Ravenna Army Ammunition Plant (RVAAP) Restoration Program

Portage/Trumbull Counties, RVAAP-69 Building 1048 Fire Station

Subject: Field Change Notice

CC RVAAP-69 Building 1048 Fire Station Former Ravenna Army Ammunition Plant

Carbon Tetrachloride Detected in Subsurface Soil Samples

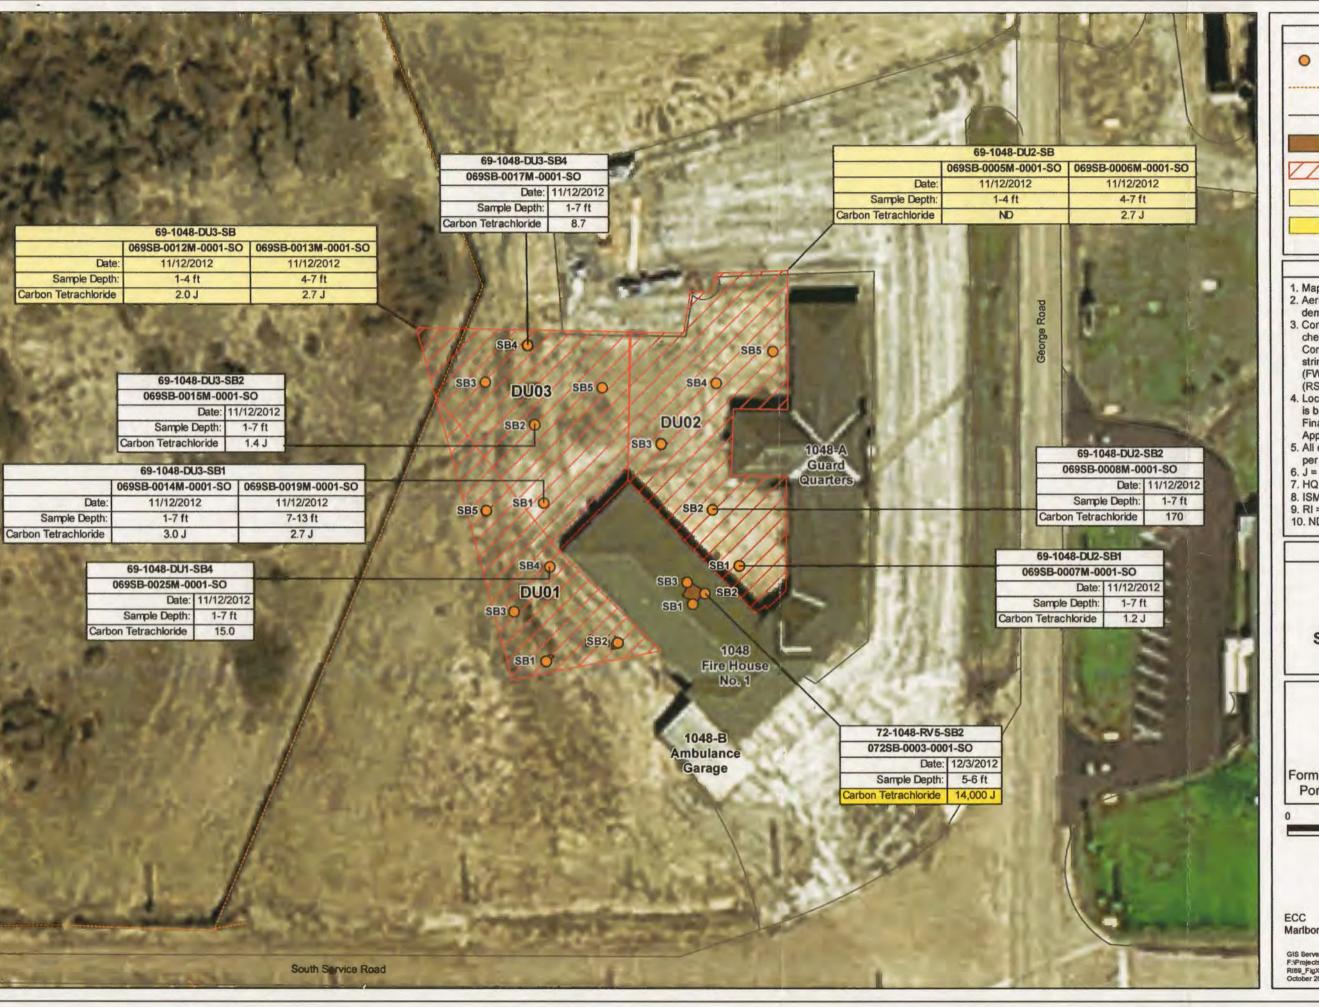
Carbon tetrachloride was detected at a concentration of $14,000 \, \mathrm{J}$ micrograms per kilogram (µg/kg) in the subsurface soil sample collected from five to six feet below ground surface in soil boring SB2. There is no Facility-Wide Cleanup Goal (FWCUG) for carbon tetrachloride, but there is a Regional Screening Level (RSL) of 610 parts per billion (ppb). As a result of this detection of carbon tetrachloride in this subsurface soil sample, the nature and extent of carbon tetrachloride has not been defined for the current Remedial Investigation. Additional subsurface soil samples are required to define the nature and extent of the carbon tetrachloride at SB2.

Proposed Subsurface Soil Boring Locations

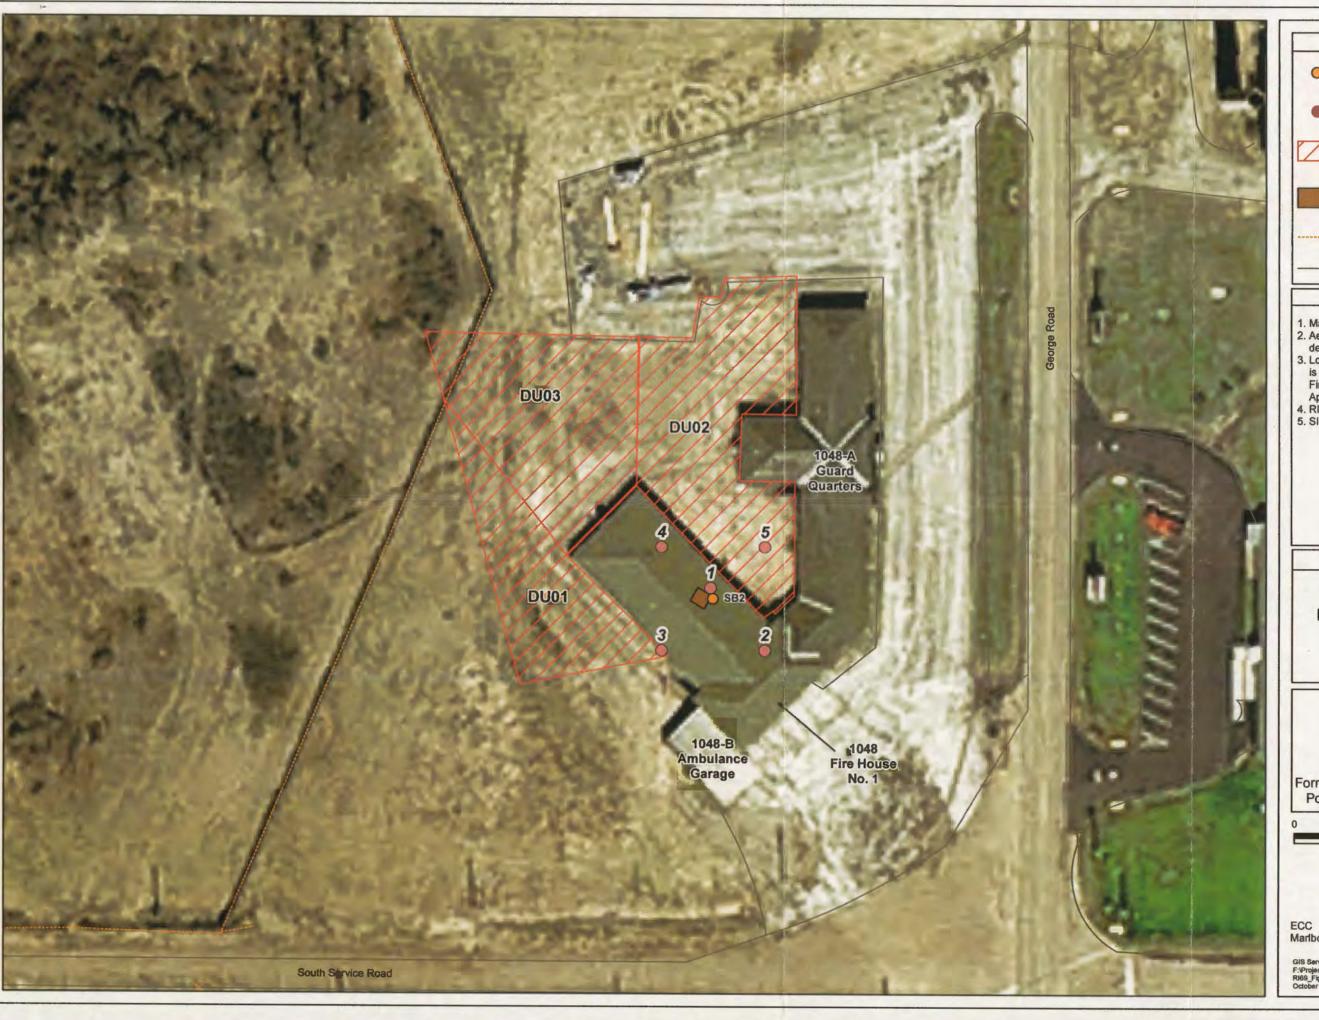
Five soil borings are proposed to delineate the nature and extent of the detection of carbon tetrachloride at SB2. These soil borings are presented in Figure 2. Discrete subsurface soil samples will be collected at several depth intervals from each soil boring. The soil samples will be submitted for laboratory analysis for volatile organic compounds (VOCs) using United States Environmental Protection Agency (US EPA) Method 8260B. Table 1 presents a summary of the soil borings and the anticipated subsurface sample intervals from each soil boring.

Soil Boring No.	Sample Intervals (ft bgs)	No. of Samples per Interval	Sample Rationale
1	2-3	1	Define nature and extent of carbon tetrachloride detected in SB2 as shown in Figure 2. This boring would replicate SB2 sampling and obtain samples for vertical delineation at this boring location.
	5-6	1	
	7-8	1	
	12-13	1-	
2	2-3	1	Define nature and extent of carbon tetrachloride detected in SB2 as shown in Figure 2.
	5-6	1	
	7-8	1	
3	2-3	1	Define nature and extent of carbon tetrachloride detected in SB2 as shown in Figure 2.
	5-6	1	
	7-8	1	
4	2-3	1	Define nature and extent of carbon tetrachloride detected in SB2 as shown in Figure 2.
	5-6	1	
	7-8	1	
5	2-3	1	Define nature and extent of carbon tetrachloride detected in SB2 as shown in Figure 2.
	5-6	1	
	7-8	1
